Gath Memorial Pool Improvements
256 Albemarle Rd,
Newton, MA 02460

NEW HATCH @ EXISTING SURGE TANK

REFERENCE: D100/SD33, D101/4

SK02

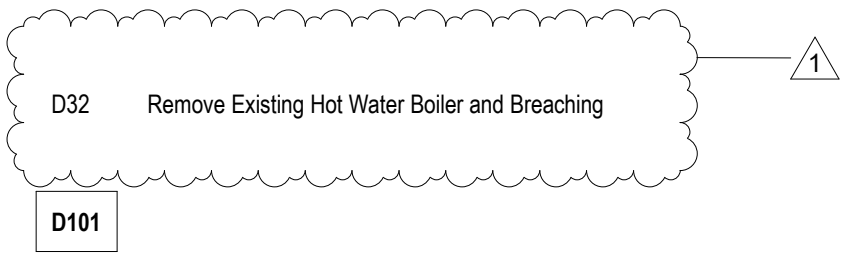
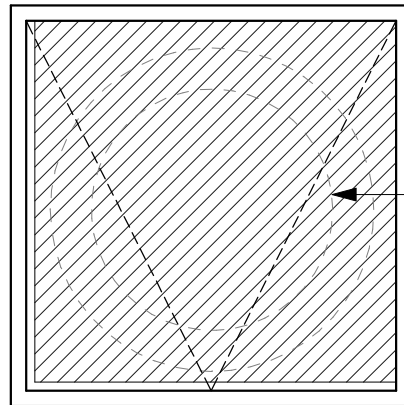
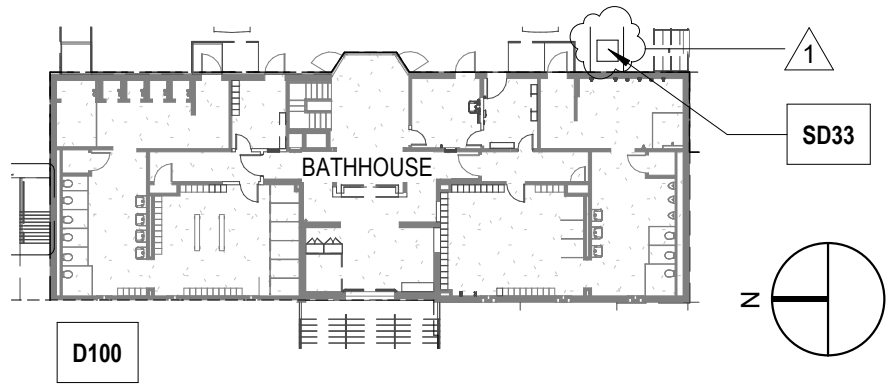
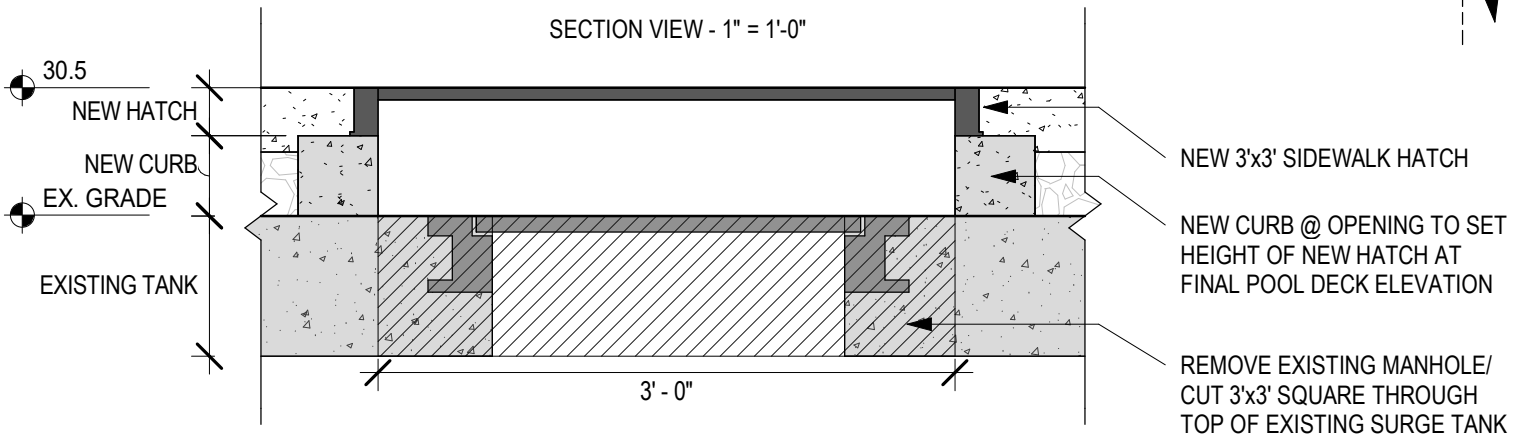
NEW 3'x3' SIDEWALK HATCH

REMOVE EXISTING MANHOLE AND CUT 3'x3' SQUARE THROUGH TOP OF EXISTING SURGE TANK

D101 ADD:

SD 33 Remove existing manhole @ existing storm surge tank, cut existing concrete to accomodate new 3'x3' hatch door

E101

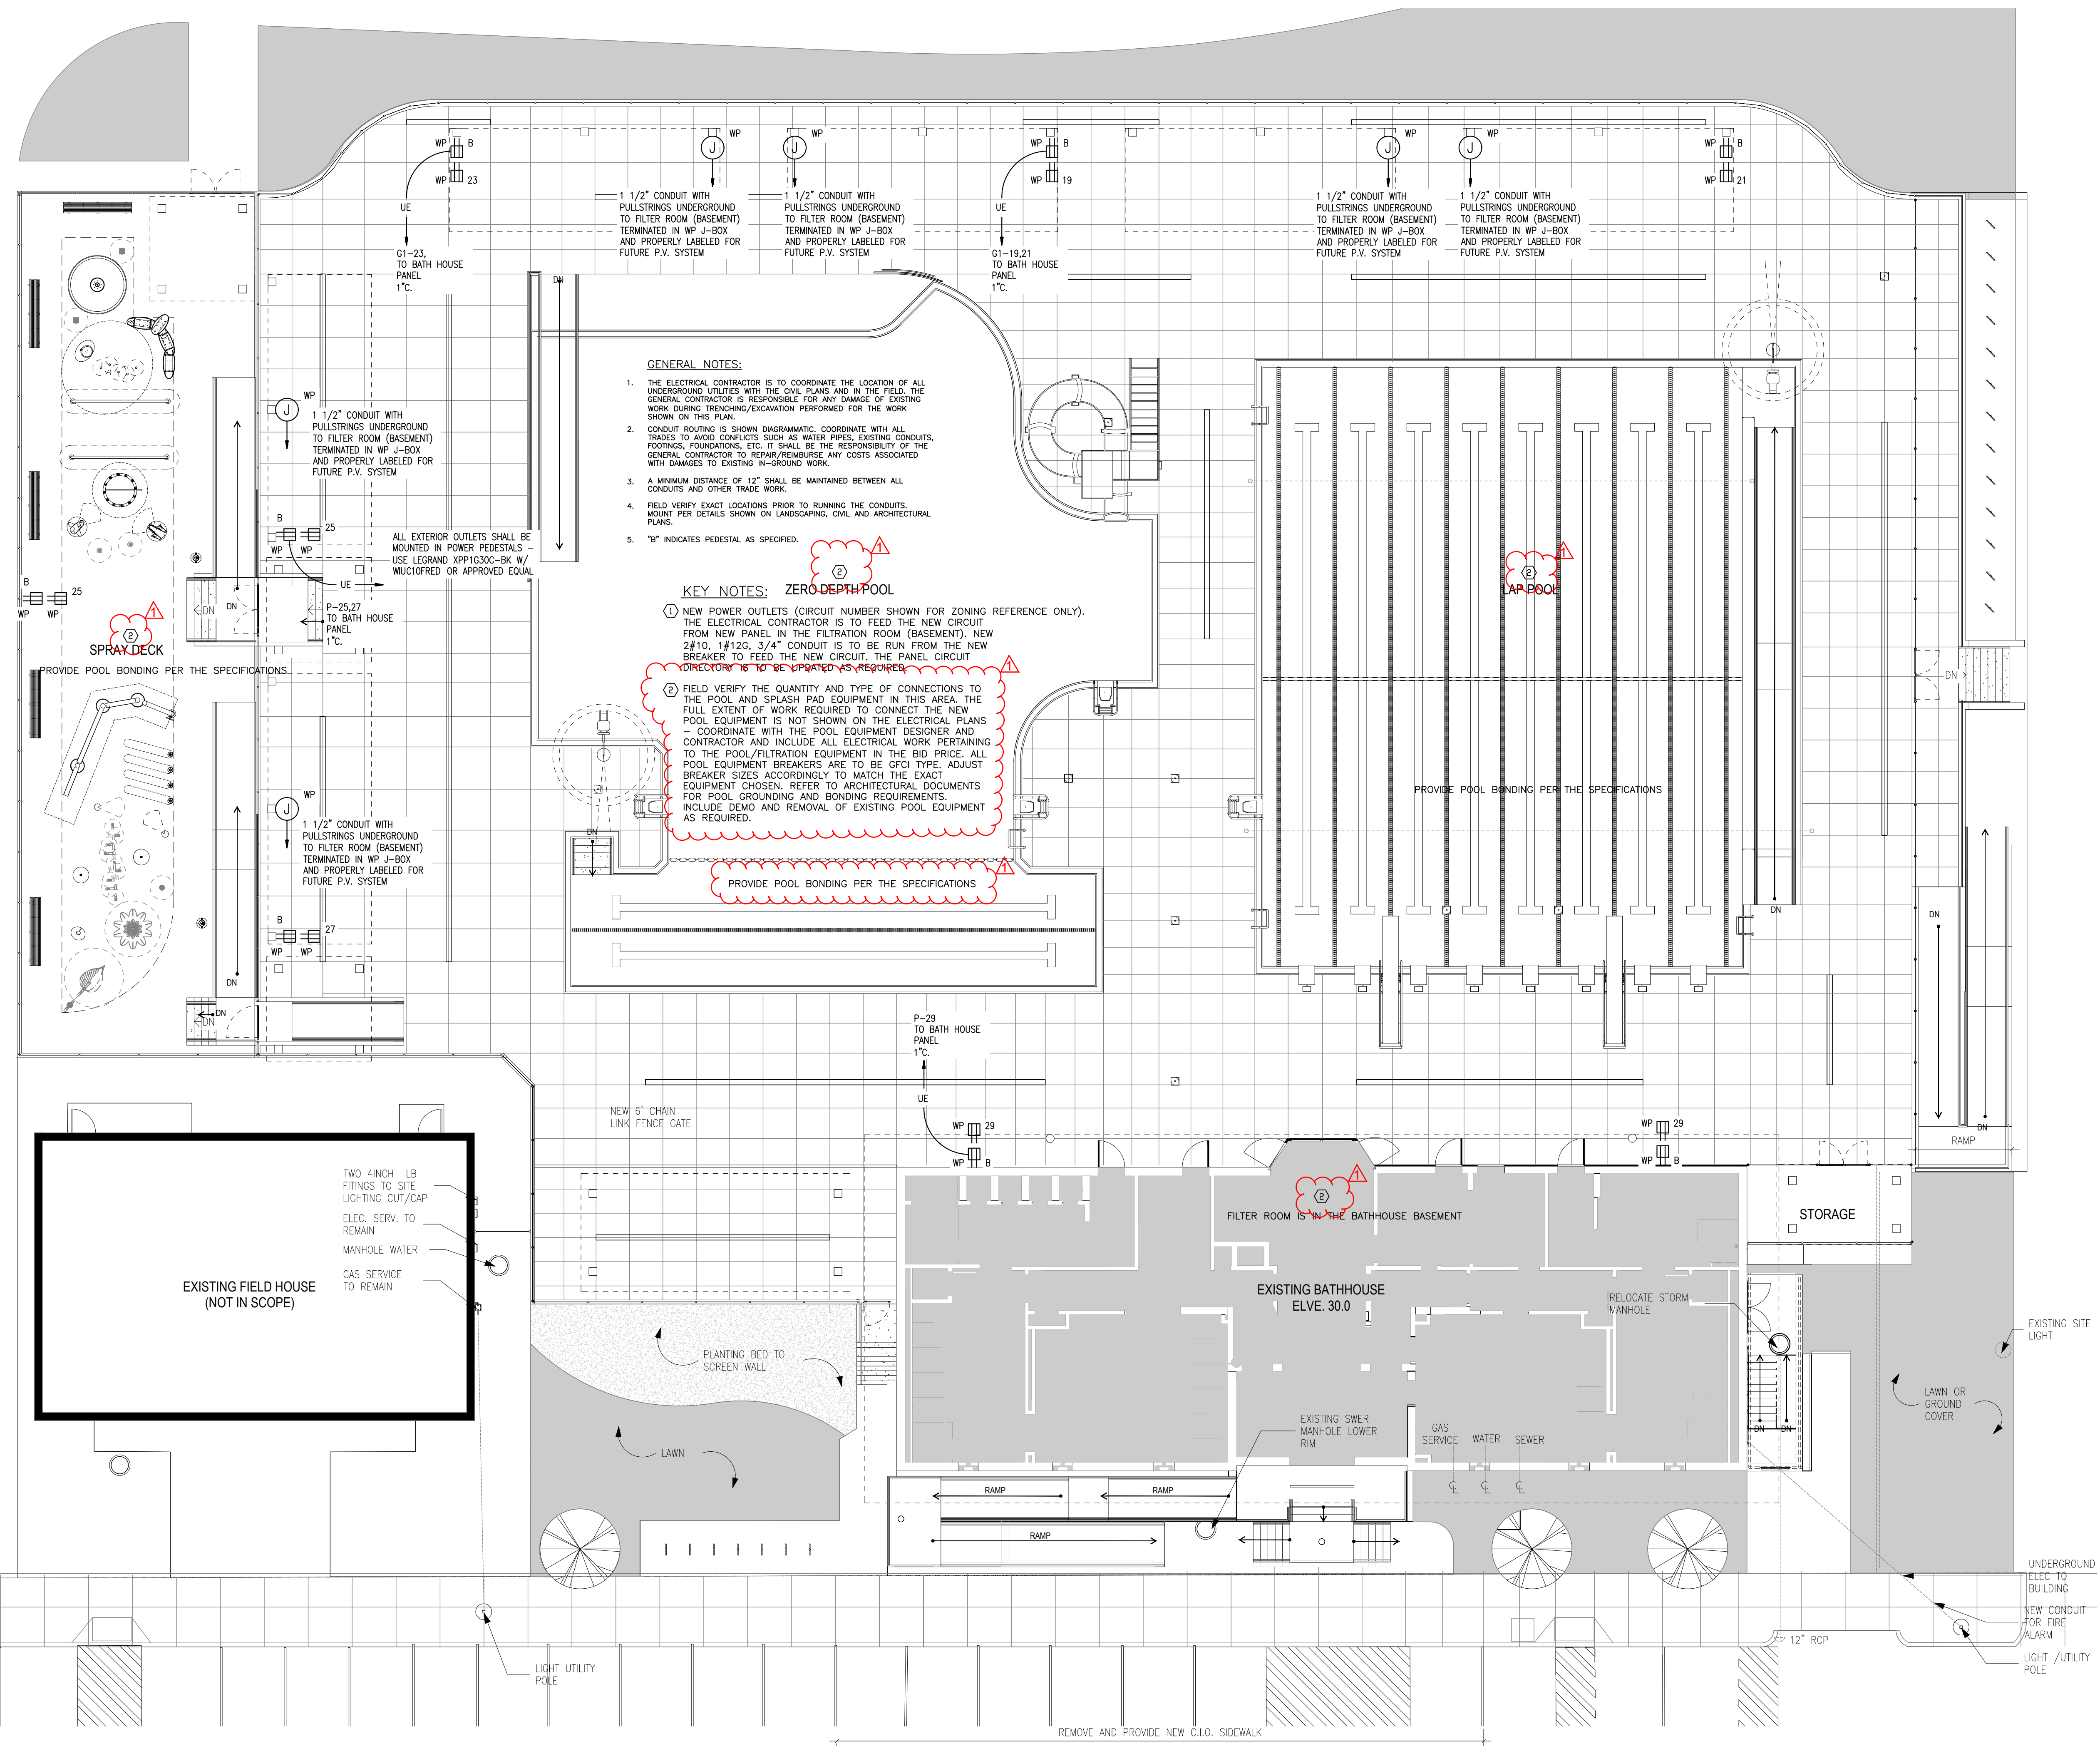
NO.	DESCRIPTION	DATE
1	ADDENDUM 1	7/21/23
